From: Kevin Sutton <ks@davies-sutton.co.uk>
Sent: 03 January 2023 12:28
To: Cross, David
Cc: Rogers, Gareth; Thomas, Zoe (Regeneration)
Subject: Re: YMCA Planning Conditions [NOT PROTECTIVELY MARKED]
Attachments: 02 YMCA Landscape Layout 16.12.22.pdf

Condition 3: The updated site layout plan (3510_GA200 Ref F) was submitted highlighting the proposed soft landscaping, comprising hedgerows and trees to benefit commuting/foraging bats. With reference to the email below, I understand you are still waiting for information on this scheme. The planting scheme needs to be provided setting out the details i.e. plant species and mix, planting sizes and ground preparation etc. Can you give me a timeframe on when this information can be submitted?

Project	Date	Scale	Drawn
YMCA Landscape Scheme	December 22	1:100@A2	JJ

Drawing Title	Job No.	Drawing No.	Revision
Soft Landscape Layout	2202/MH	02

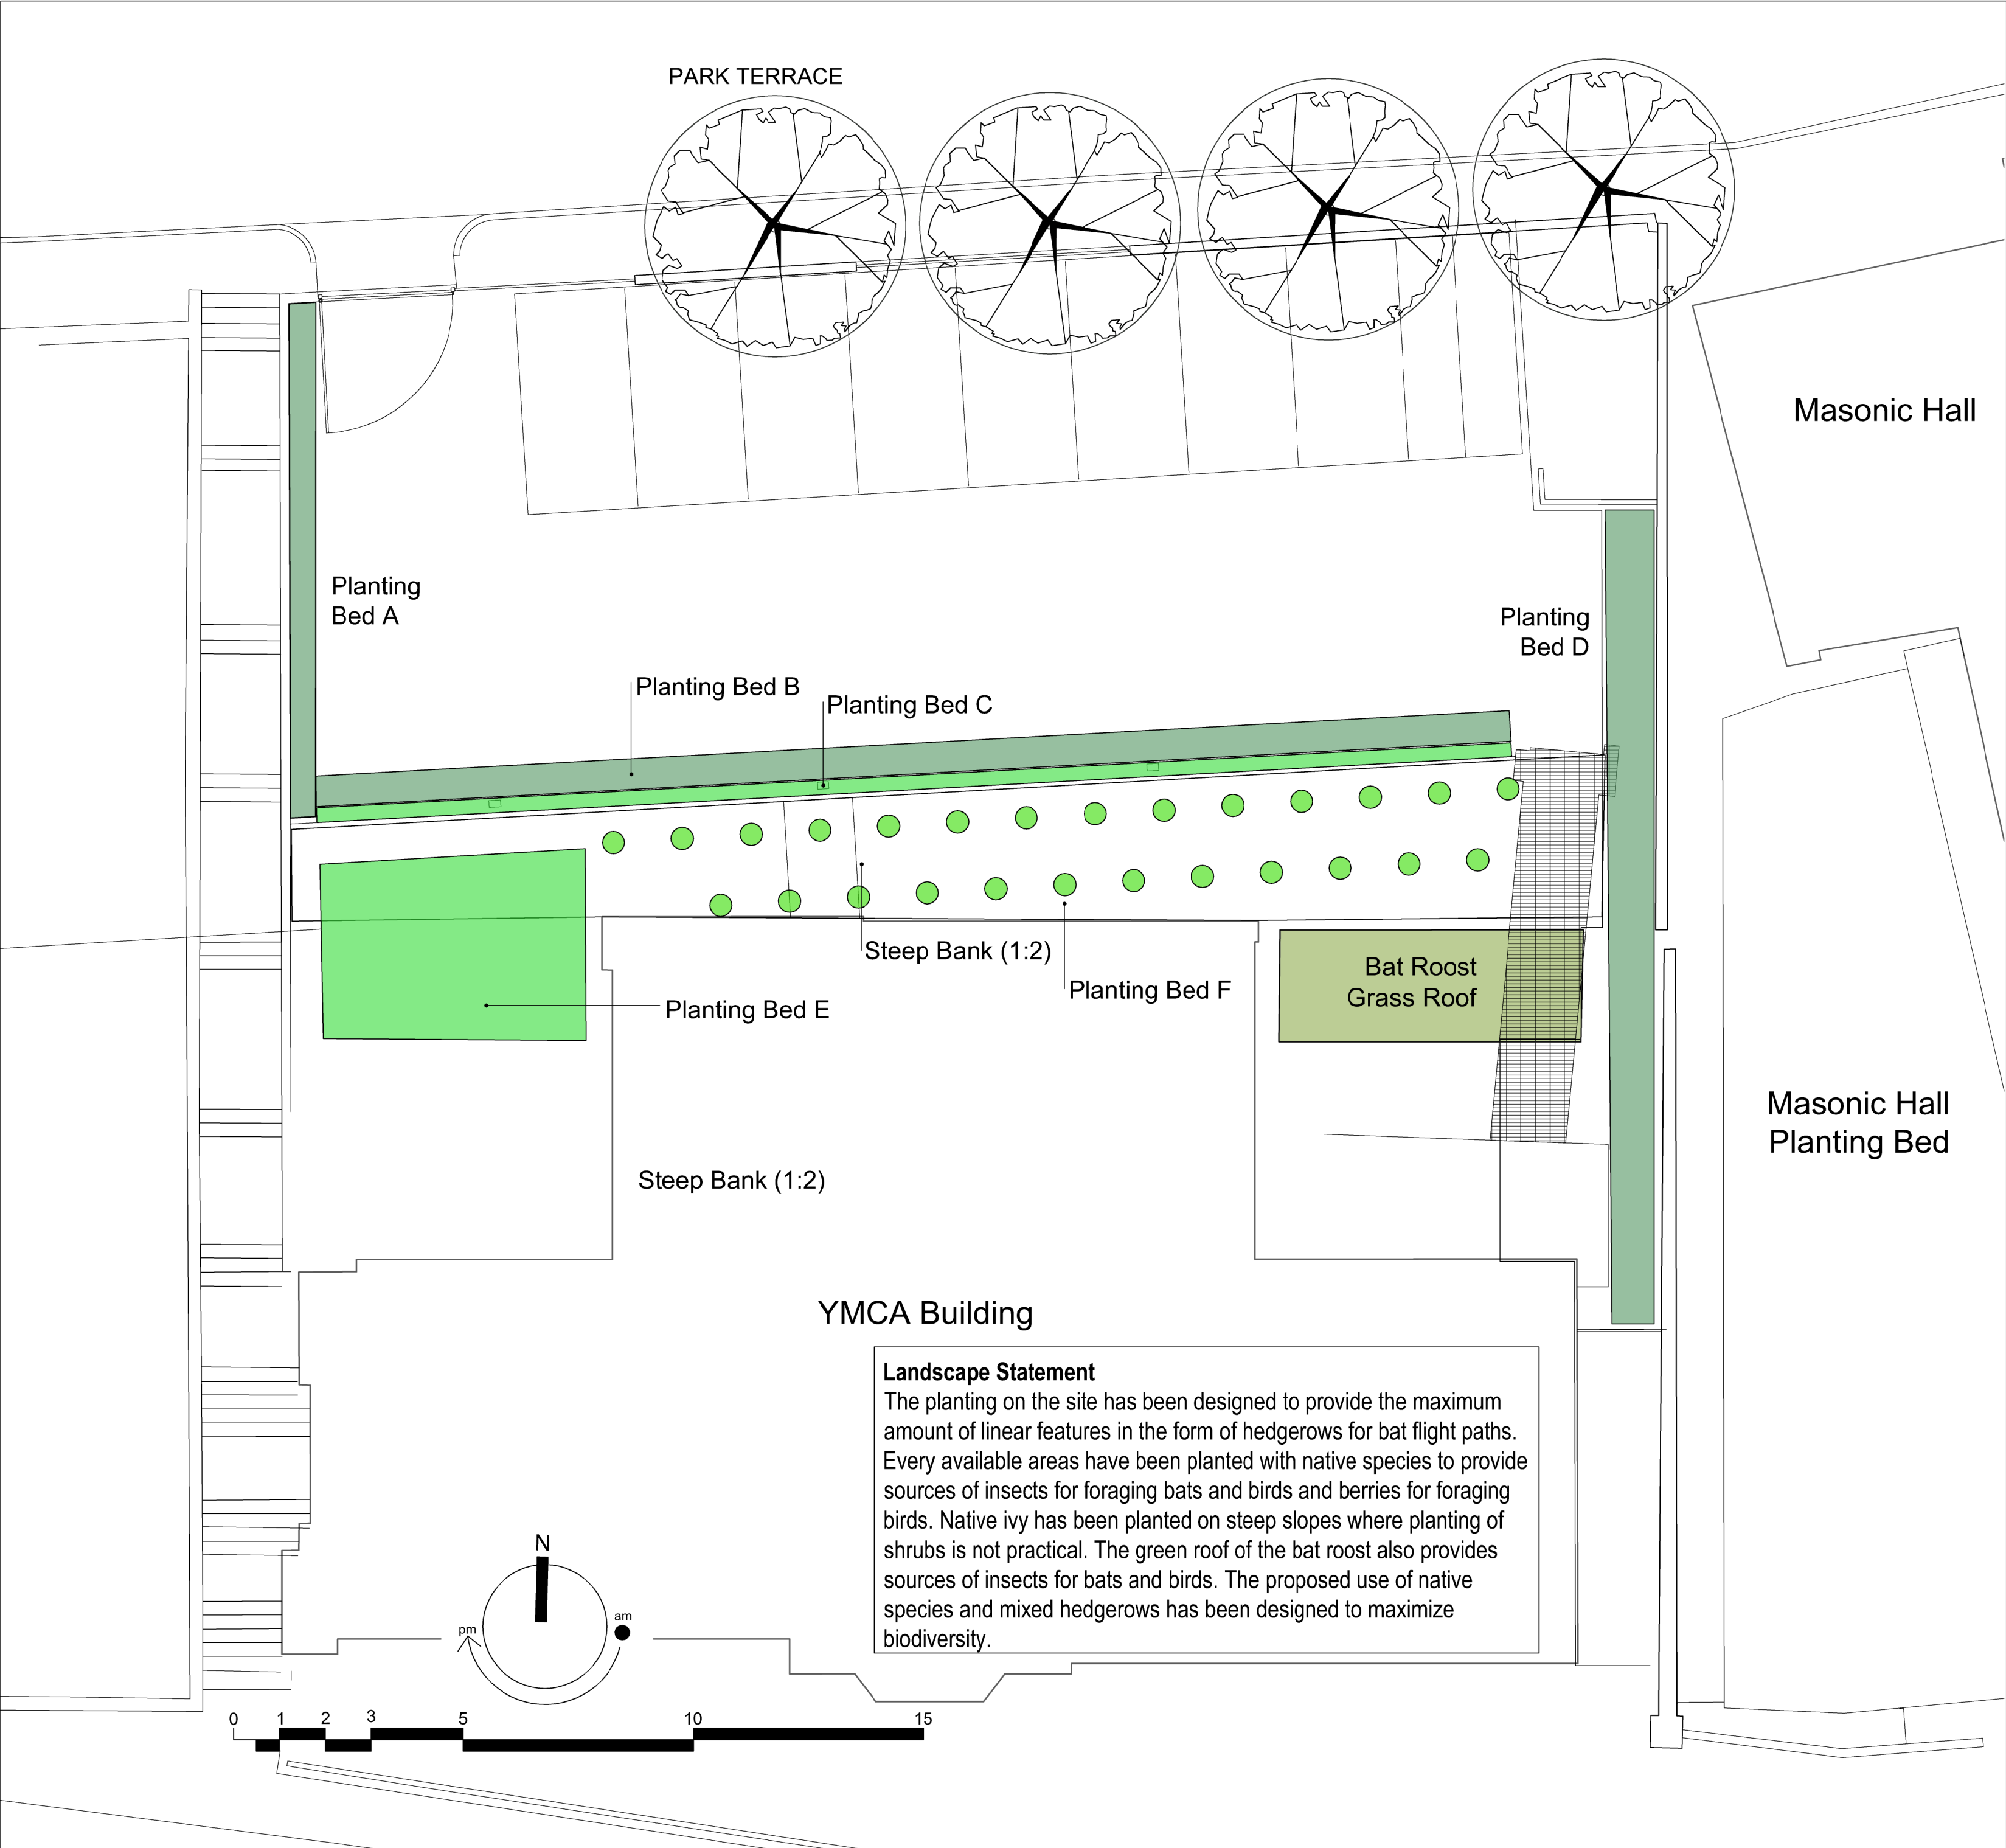
There doesn't appear to be any landscape plan attached with your email. Could you send this across to me again please.

Please see the attached drawing 2202/MH, being the landscape architects soft-landscaping proposals. I trust this now enables you to discharge this condition.

The planting on the site has been designed to provide the maximum amount of linear features in the form of hedgerows for bat flight paths. Every available areas have been planted with native species to provide sources of insects for foraging bats and birds and berries for foraging birds. Native ivy has been planted on steep slopes where planting of shrubs is not practical. The green roof of the bat roost also provides sources of insects for bats and birds. The proposed use of native species and mixed hedgerows has been designed to maximize biodiversity.
